LOUISIANA
POWER & LIGHT

W3P83-0320

SUBJECT: Waterford 3 SES
Docket No. 50-382
Formal Transmittal of
Official EQ Audit Record

ENVIRONMENTAL QUALIFICATION AUDIT REVIEW SHEET

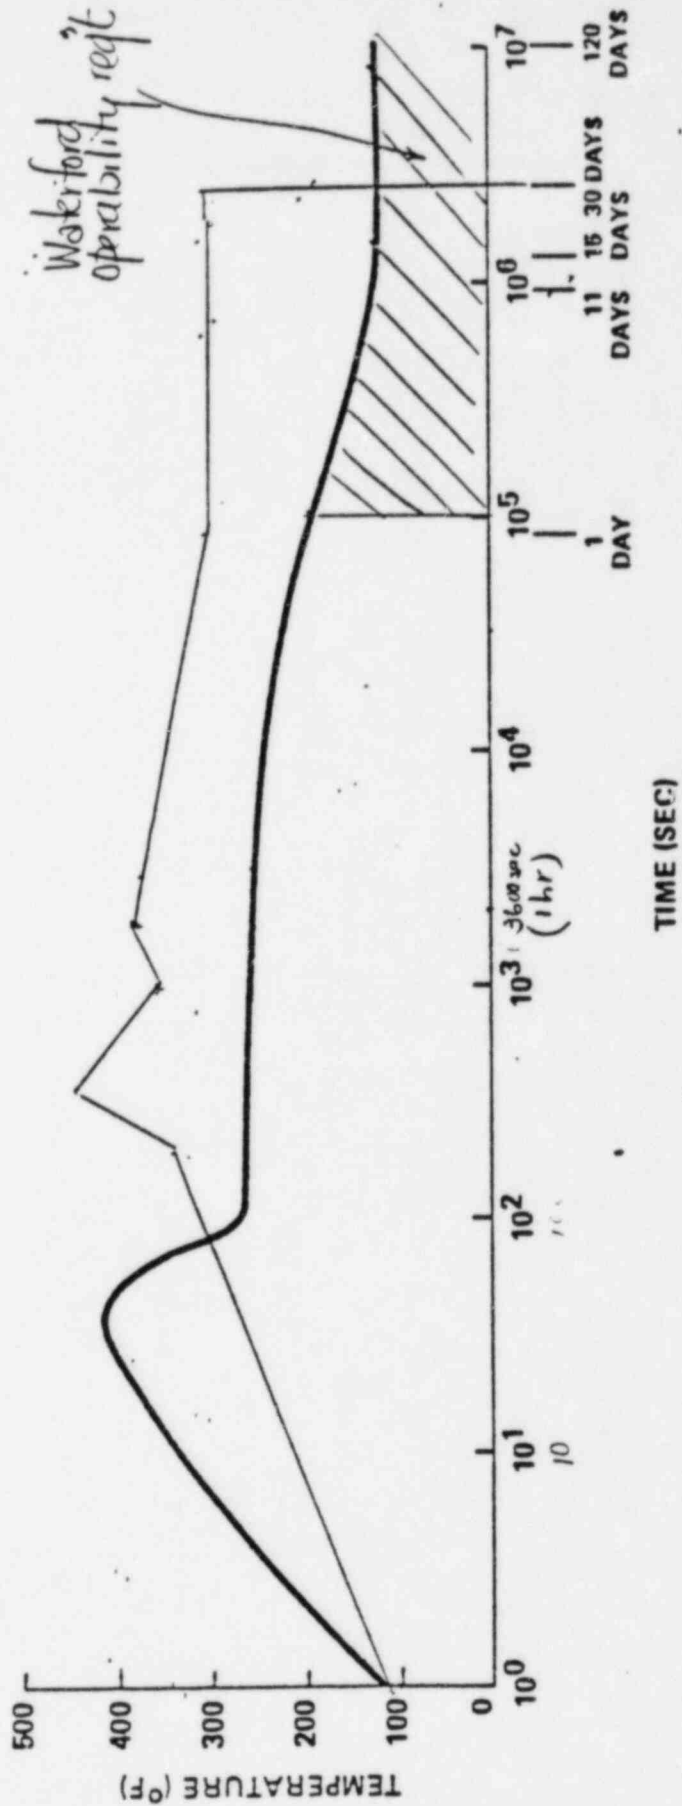
5) Is there analysis showing that the peak DBA temperature is "covered" by a lower test temperature?	5) Test Data Base 2 tested the sample to a peak temperature of 405.5°F for 90 seconds as opposed to the short transient Waterford peak temperature of 414°F for 55 seconds. Conax references IPS-694 which states that during the MSLB transient the penetration will never exceed the corresponding saturated steam temperature corresponding to the MSLB temperature and pressure. (e.g. for a 418°F and 44 PSIG the equivalent is 291.6°F. This is the MSLB equivalent transient for the tested penetrations. This envelopes the 414°F Waterford transient. CLOSED

Furthermore, on July 7-10, 1981, NRC held public meetings on NRC Requirements regarding the Environmental Qualification of Safety-Related Electrical Equipment (Federal Register Notice Vol. 46, No. 112, page 30925). In the course of the July 7-10 meetings, Dr. L. L. Bonzon of Sandia National Laboratories (the Program Manager of the Qualification Testing Evaluation Program being conducted for the NRC's Division of Engineering Technology), presented actual test data which clearly demonstrated the significant "thermal lag" for safety-related components.

Figure A-3 from the EQ Guidebook (attached) is a reproduction of the test (Catawba Penetration Test) data presented which demonstrates that thermal equilibrium is not achieved for many minutes in real time conditions (versus the time in seconds when the WSES-3 MSLB temperature exceeds the LOCA temperatures.) This test result validates the use on a "case-by-case basis" of the temperature of the crucial component in lieu of equipment surface temperature by test or analysis as clarified by NUREG-0588 Revision 1 comments and resolution to NUREG-0588, paragraph 1.2(5).

In addition, the analyses used remain very conservative as no credit is taken for the substantial thermal resistance of the enclosure's internal ambient. Actual "real world" tests (Figure A-3) demonstrate the additional lag on the conductors surface (i.e. the surface of concern for qualification). CLOSED

Arrhenius Eq.

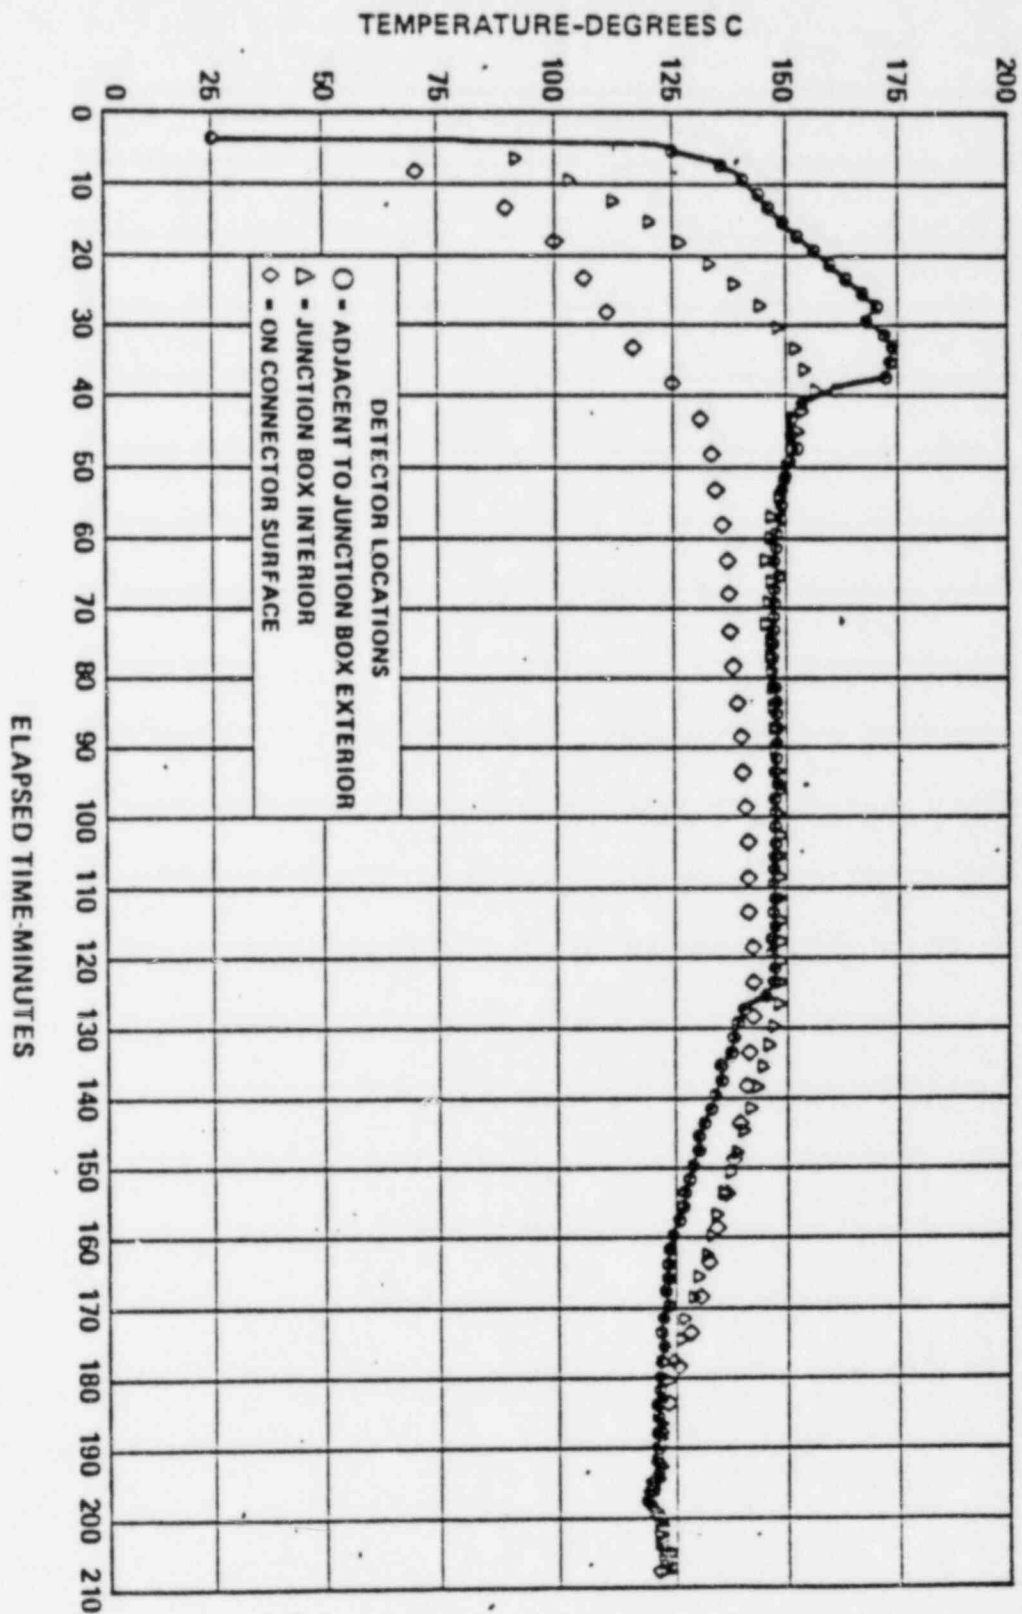
COMMENTS	RESOLUTION
4) Is there analysis showing the extrapolation of test data to the required operability time?	4) The required operability time of the Penetrations is 120 days at 120°F. The test samples were held at a temperature of 300°F average for 30 days (288 hrs.). As seen on the attached Arrhenius Plot for Kerite, 288 hours at 300°F is equivalent to 24,586 hours (1024 days) at 200°F. The 300°F temperature for 30 days exceeds the operability requirement by sufficient margin as seen on the attached graph. In addition, the above curve is based on results assuming continuous energizing of the equipment. It is noted that these penetrations are dedicated for power to the Reactor Coolant Pumps. These pumps do not operate during plant shutdown and all pumps do not operate continuously further adding to qualified life. Also, the Reactor Coolant Pumps do not perform a safety function and do not operate during a Design Bases event - the cables will be de-energized during Post LOCA and the Penetrations will act as a seal between the RCB & RAB. This further adds to the qualified life. CLOSED

Fig. 3. Accelerating Effect of Temperature on SIC Values During Water Immersion

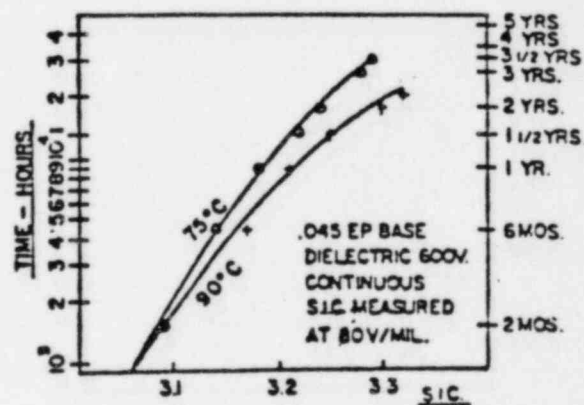
- 1) The QDEF sheet states cables are assumed to be in worst case environment, submerged and demonstrated acceptable however, the aged cables were only submerged for 5 min. post loca.

Fig. 3 not only shows the SIC values for an ethylene-propylene base insulation during a long term continuous water immersion study, but also the accelerating effect of temperature as manifested by a change in the 60 cycle capacity. The 142°C/42 psig steam autoclave exposure further accelerates the increase in the SIC value but could change the reaction mechanism. In any event, if plotted on Fig. 3 the end point is still some two years out on the time scale.
